Technical Service Bulletin

55K6 UPDATE – Servicing Rear Lid Drive (NVLW)

November 08, 2019

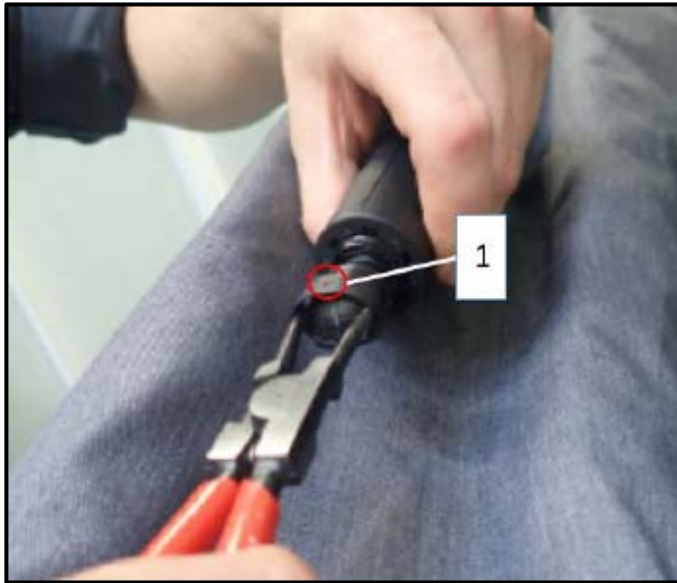
- Open the rear lid.
- Support the rear lid to prevent it from dropping down.
- Use a small screwdriver to lift securing clip <1> slightly and detach spindle motor from ball stud on body and rear lid.

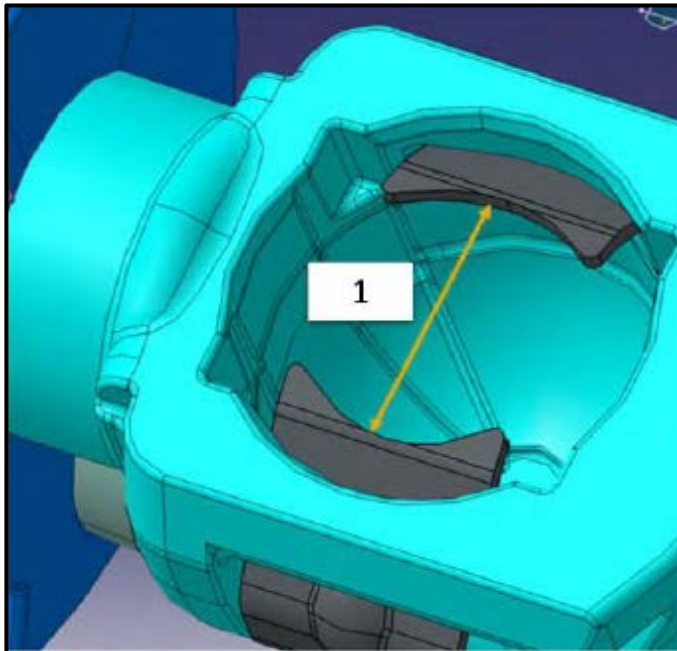
After removing securing clip, check plastic ball socket visually for damage.

- The securing clips on both ends of both spindle motors are being replaced.
- Grip new securing clip (with collar <1>) with circlip pliers and slide over assembly slot into end position. Securing clip must be seated firmly on ball socket (there should be no play).

- Check radius <1> of securing clip using caliper gauge.
- Do not apply excessive pressure to securing clip during the measurement.
- Opening dimension = 7.4 mm – 9.0 mm.
 - If the dimension is not correct, the clip must be installed again.
